PRODUCT CHANGE NOTIFICATION

#PCN-ICT-FNAG-12

The article description of all existing Push In Terminals from PIT xx to PT xx.

Previous Product	New Product
Current Production State	New Production State

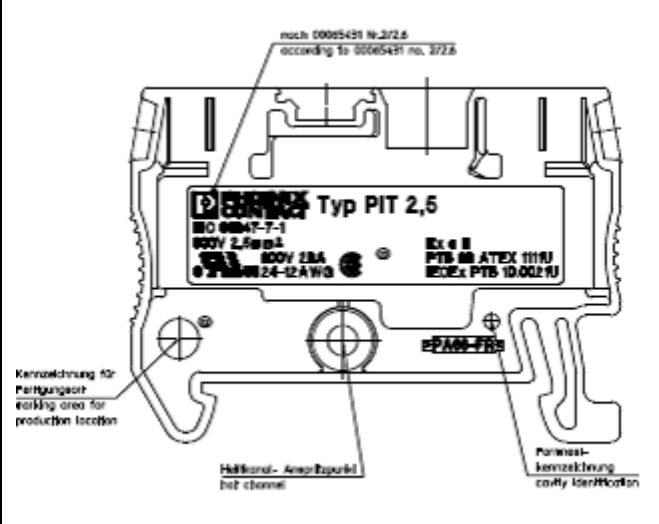
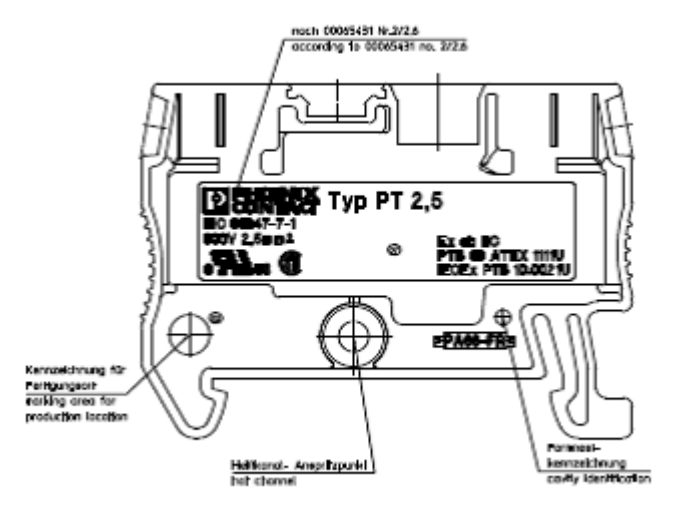
Sample: 'old' 3209510 PIT 2,5 / 'new' 3209510 PT 2,5
